GREAT LAKES INDIAN FISH AND WILDLIFE COMMISSION

January 31, 2017

Thank you for the opportunity to comment on the draft NPDES permit for the US Steel Minntac facility. These comments follow up on, and expand on, my email of December 23rd, 2016 and represent GLIFWC staff comments on the proposed permit and associated Fact Sheet.

Figure 6. Figure 2 of CRA report titled: "Estimate of Time of Travel between the Tailings Basin and the Twin Lakes Minntac Tailings Basin, United States Steel Corporation, Mountain Iron, Minnesota. July 11, 2013."

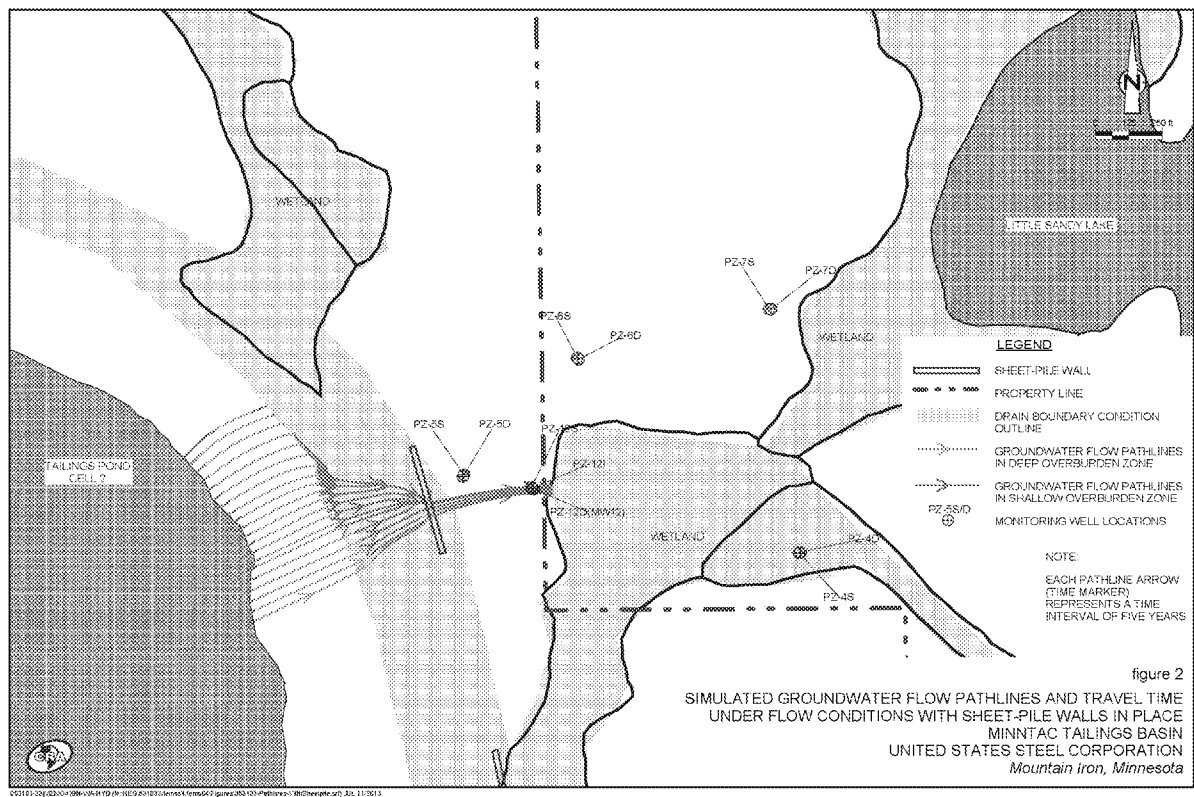
The concept, proposed in the Fact Sheet, that deep seepage travels substantial distances underground to receiving waters such as the Twin Lakes may be partially true, yet does nothing to address the fact that much, if not most, seepage never travels any significant distance through the underlying aquifer but discharges to surface waters immediately adjacent to the basin berm and is not captured.

It is not surprising that there are upward gradients and discharge near the toe of the basin dam. Why would basin water remain trapped below the land surface in the relatively thin surficial aquifer and travel to distant surface water features? Head pressures, and the path of least resistance, would quickly drive the water to the land surface where it can flow easily as surface water. Particle tracking in CRA's second report (CRA, 2013b and attached Figure 6) indicates that water from the basin would discharge to the nearest available wetland. Although CRA did not do particle tracking near the headwaters of the Sand River and Admiral Lake (adjacent to SD002), the conclusion would certainly be the same: discharge to the nearest available surface water feature. The nearest ponded features and wetland to the basin dike in that area abut the dike.

Figure 7. USGS topographic map published in 1951, based on aerial photos from 1947, showing the origin of the upper Sand River in a wetland that is currently covered by the Minntac tailings basin. County Hwy. 568, which is no longer passable, is visible just west of Admiral Lake.

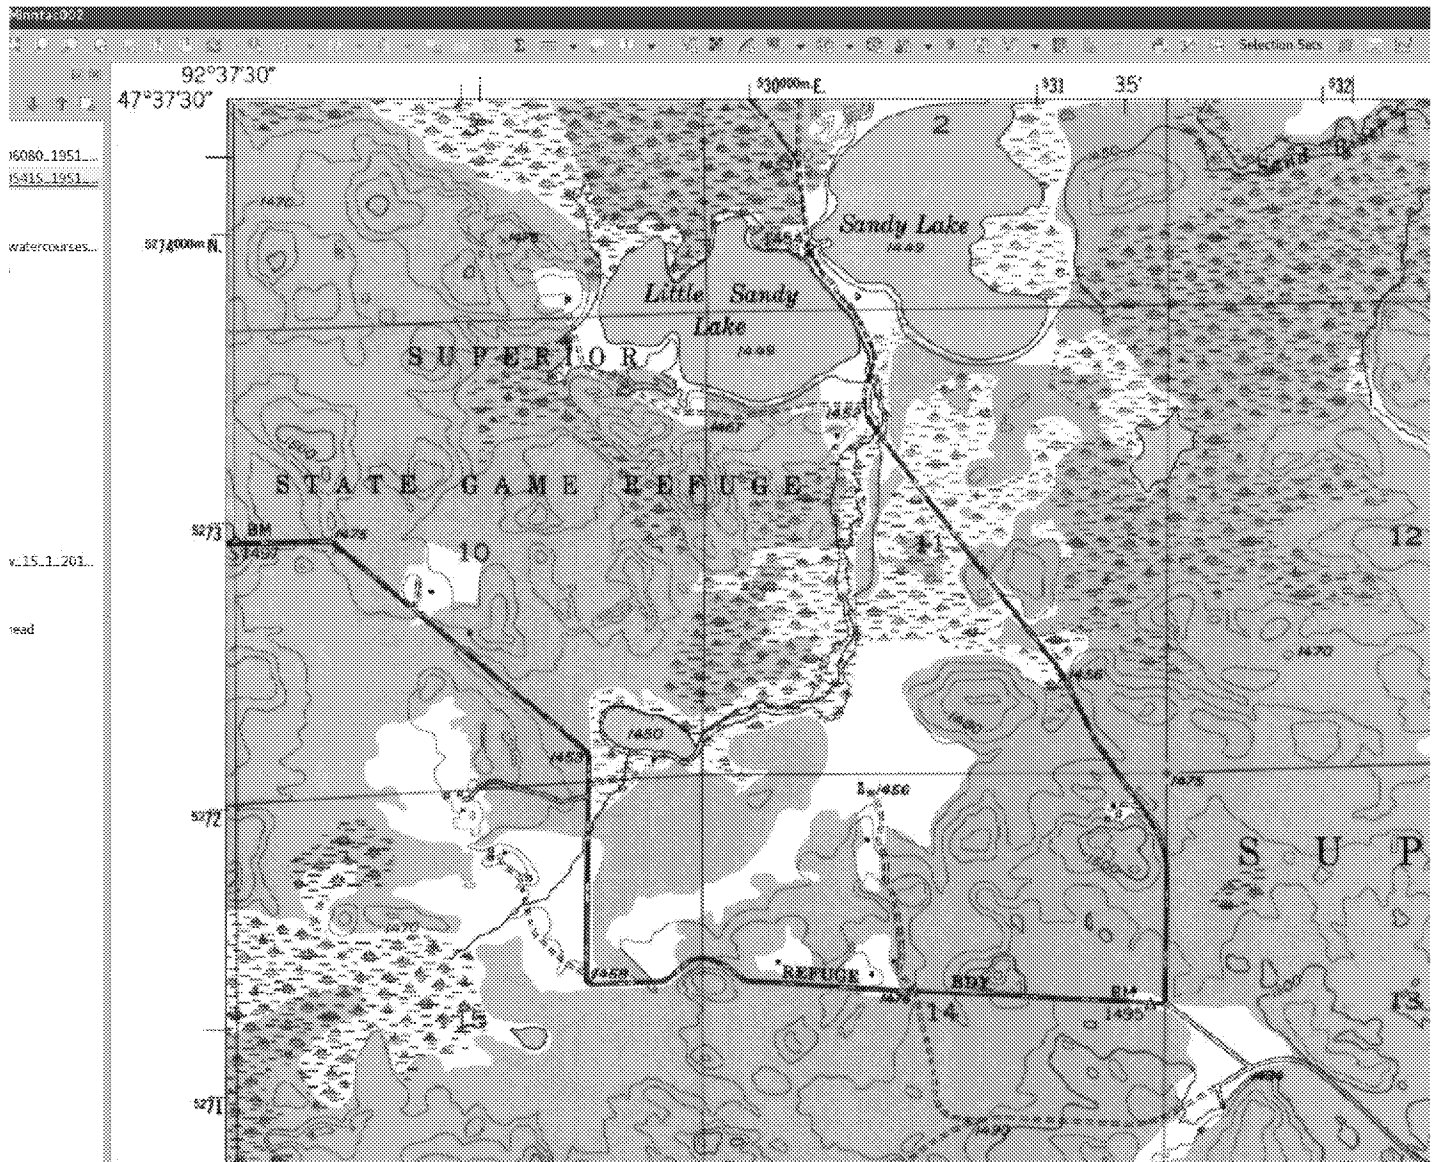
The section of Sand River flowing from the basin to Admiral Lake, and Admiral Lake itself, are represented as perennial water bodies on USGS topographic maps at least as far back as 1951 (Figure 7). While the very upper reaches of the Sand River were covered with tailings in the 1960s and '70s, the river downstream of the basin remains on state and federal maps of the area. The most recent Minnesota GIS data of state Protected/Public waters (<https://gisdata.mn.gov/dataset/water-mn-public-waters>) shows the upper Sand River as originating at the toe of the Minntac tailings basin. The latest (2016) USGS topographic map of the area continues to show the upper reaches of the Sand River and Admiral Lake as perennial water bodies (Figure 8).

The map record, dating back to at least 1951 and recent maps and aerial photographs indicate that the Sand River has its origins within feet of the Minntac tailings basin, is a perennial water body and is a Minnesota Protected/Public Water. As such, water quality and water quantity in this water body must be protected from Minntac tailings basin discharges.
